Peat Depth

Mossy Hill Wind Farm

Non-Material Variation to 2023/084/VCON (2018/186/PPF)

Figure 2c

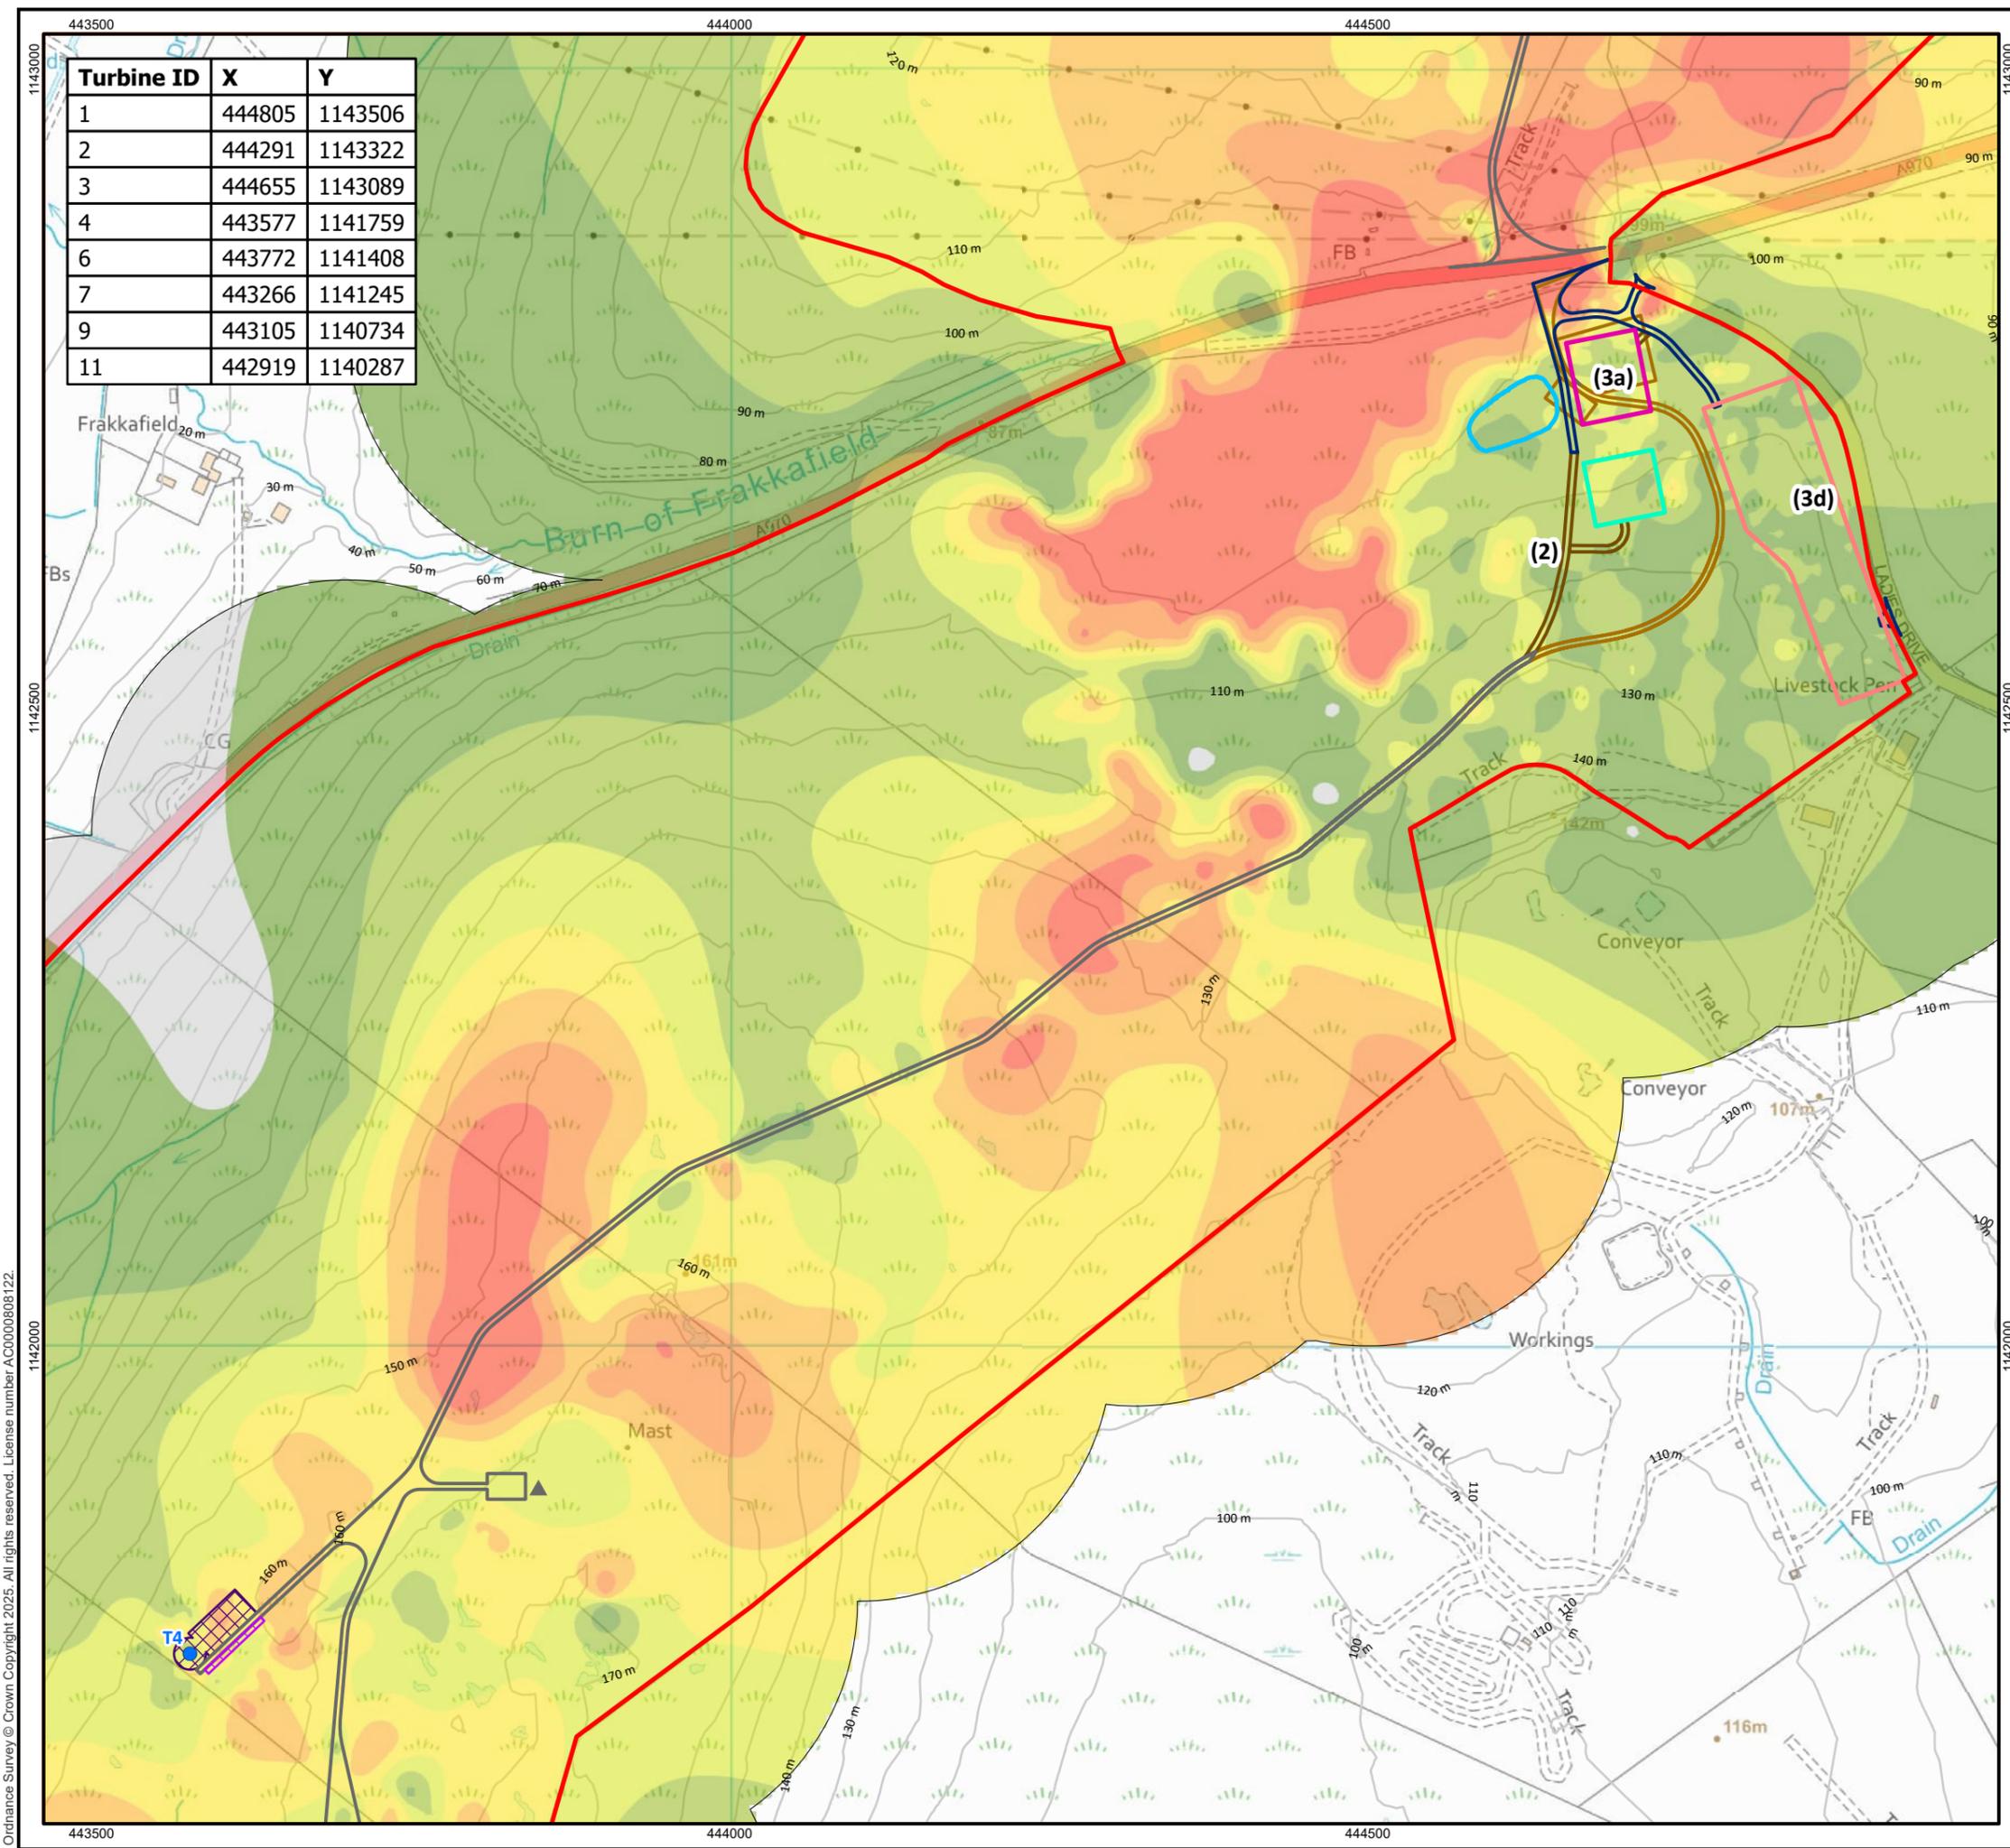
- (1) Removal of Turbines T5, T8, T10, T12, associated infrastructure, tracks and the B9073 access junction
- (2) Amendment to the track linking the consented substation to wind farm track, removing loop and shortening length. Addition of link tracks to construction compounds
- (3a) Relocation of northern wind farm temporary construction compound
- (3b) Removal of southern temporary construction compound
- (3c) Removal of southern substation
- (3d) Revised substation design and layout as approved via planning permission Ref: 2024/303/PPF granted on 12th June 2025

Figure 2d

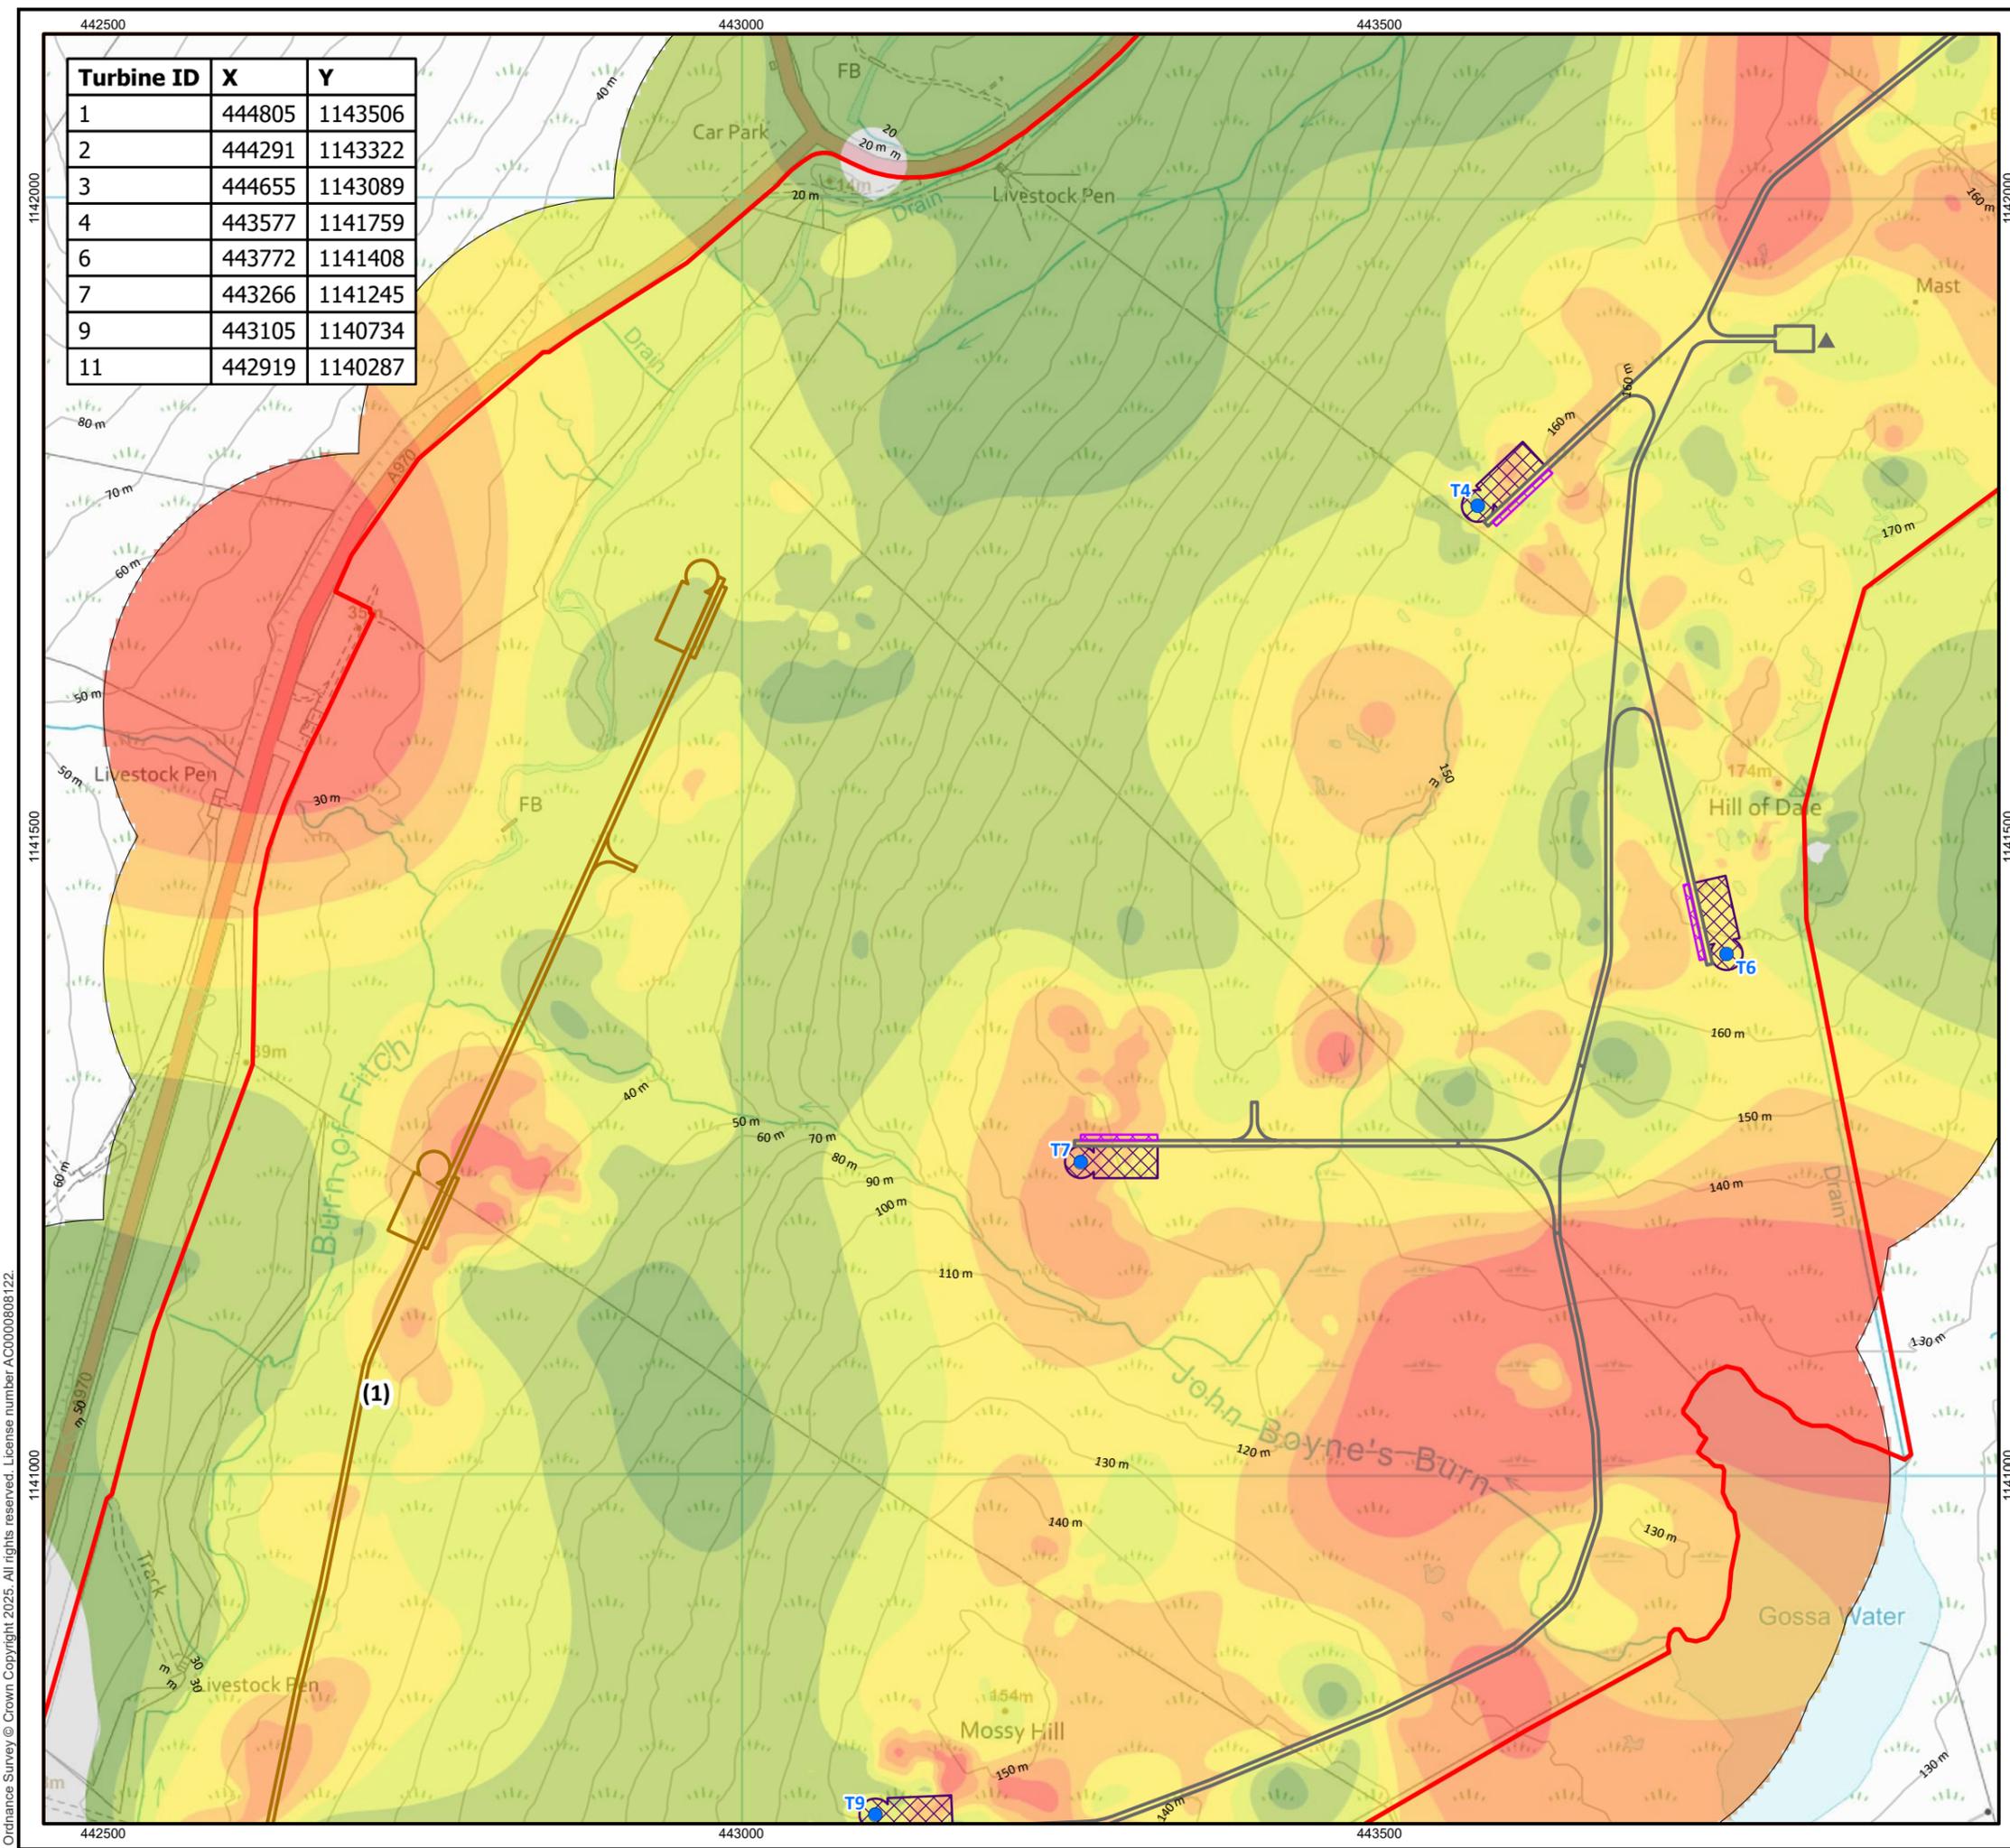
- (1) Removal of Turbines T5, T8, T10, T12, associated infrastructure, tracks and the B9073 access junction
- (2) Amendment to the track linking the consented substation to wind farm track, removing loop and shortening length. Addition of link tracks to construction compounds
- (3a) Relocation of northern wind farm temporary construction compound
- (3b) Removal of southern temporary construction compound
- (3c) Removal of southern substation
- (3d) Revised substation design and layout as approved via planning permission Ref: 2024/303/PPF granted on 12th June 2025
